REPORT NAEC-91-7958

HAZARDS/FAILURE MODES AND EFFECTS ANALYSIS
MK 1 MOD 0 LSO HUD
CONSOLE SYSTEM

24 March 1980

Technical Report
Contract No. N68335-78-C-2002

FIGURE 19. HUD PROJECTION LAMP ASSEMBLY

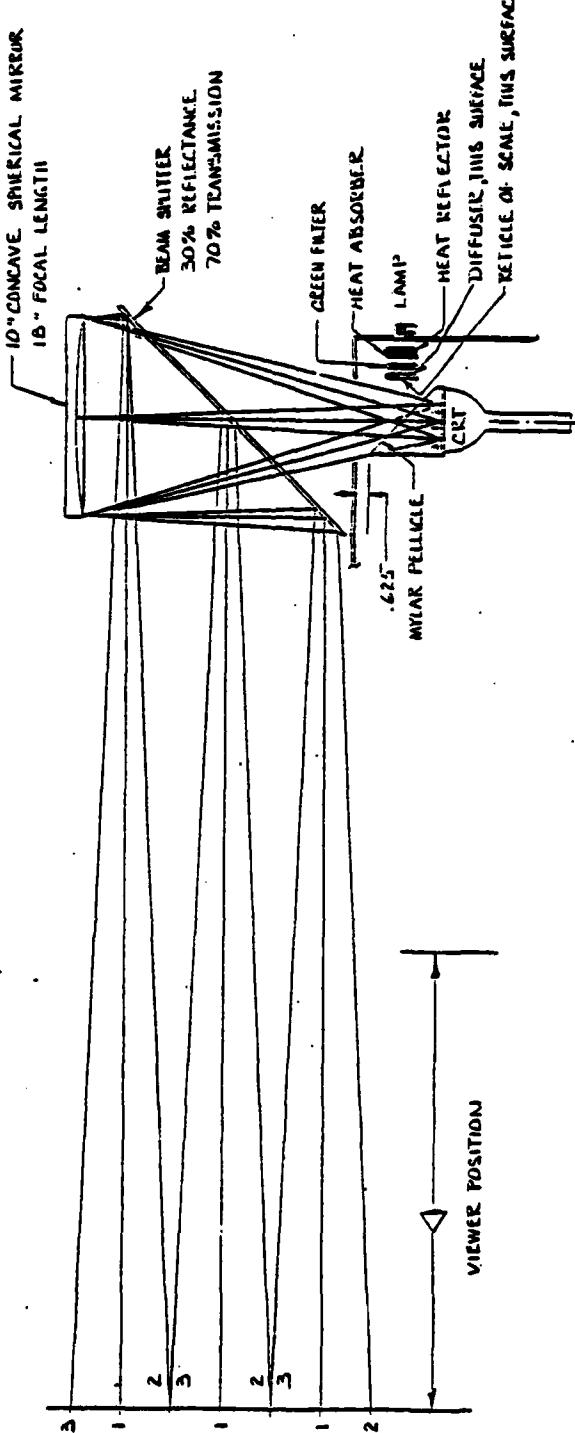
1) The projection lamp, an evacuated 50-watt glass halogen, is protected from the rear only. It can implode if shattered from the front whenever the back plate is removed from the console cabinet for maintenance (Refer to Figure 19).

FROM:

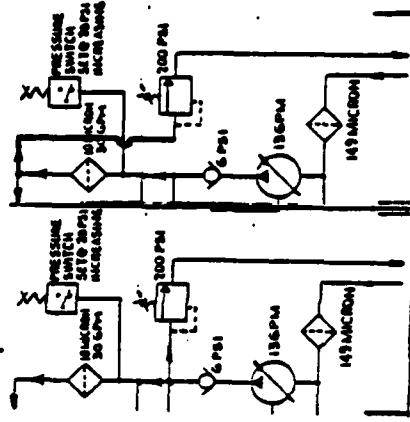
One possible way could be by changing the connection as shown in the following HYDRAULIC schematic:

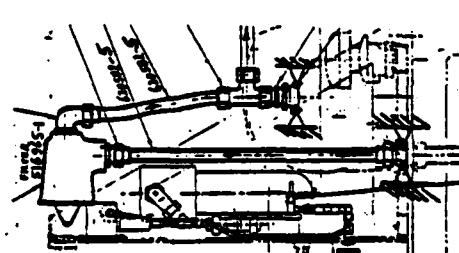
• RECOMMENDATION: Provide a tie between the upper end (the Filter 516965-1) and the Support Frame 620581-1 to eliminate or greatly reduce the vibration of the Filter.

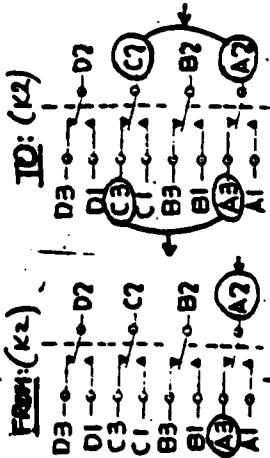
NOTE: There is an error on the sketch of the K1 and K2 pin connections in the drawing 620753-1 "Wiring Ass'y," location 4 and 5-A. See corrected sketch in Item 1.4.1, page 2 of this Table.

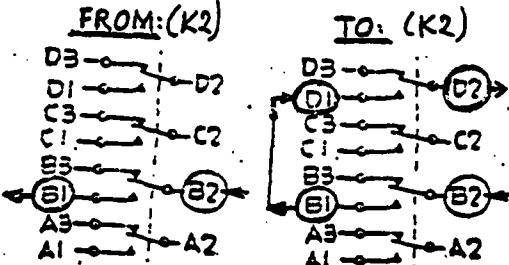
31	To increase the reliability in the K1 Relay 518915-1 against the NO contacts B failure to close, wire the K1 Relay according to the diagram below:	3A4	1.4.1. e.i	x	x	x				x x
